Pathogen Total Maximum Daily Load (TMDL) for One Segment of the East Fork of the Vermillion River South Dakota

Alan Wittmuss South Dakota Department of Environment and Natural Resources Water Resources Assistance Program

This document provides a standard format for EPA Region 8 to provide comments to state TMDL programs on TMDL documents submitted to EPA for either formal or informal review. All TMDL documents are evaluated against the minimum submission requirements and TMDL elements identified in the following 8 sections:

This draft TMDL document, "Fecal Coliform Bacteria Total Maximum Daily Load (TMDL) for One Segment of the East Fork of the Vermillion River South Dakota" was transmitted to EPA via email on May 17, 2012 requesting a formal review. This is a public notice draft document. South Dakota Department of Environment and Natural Resources (SD DENR) provided a 30-day period for public review and comment on this document.

Figure 3. Site VREF23, VREF25, and WQM150 fecal coliform concentrations for each of the five flowzones.

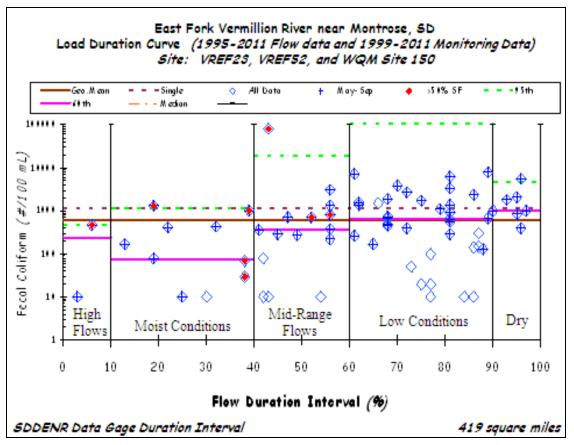
provided in Table 5. However, Figure 3, "Sites VREF23, VREF25, and WQM150 fecal coliform concentrations for each of the five flow zones" displays the results in graphical form for all 3 stations combined. Figure 3 does not relate the measured concentrations to individual monitoring locations. However, this information is provided in Appendix A, Water Quality Data.

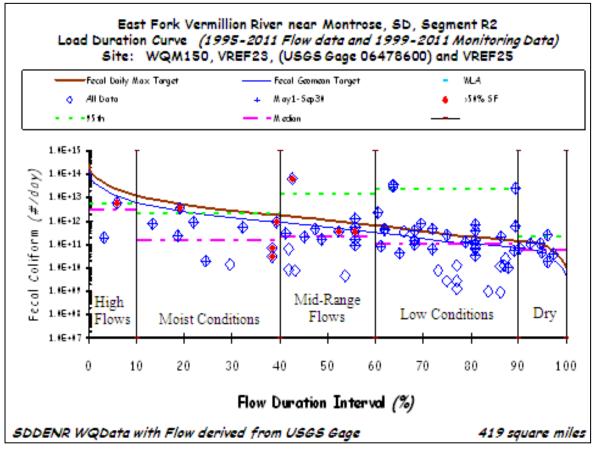
Figure 4 (page 21) presents the LDC. In the mid range, low, and dry flow zones, the measured loading exceeded the allowable loading (based on a water quality target of <1000 cfu/100mL) during some sampling events. Loads in the low flow zone typically indicate a point source load or livestock defecating in the stream or inputs from failing septic tanks.
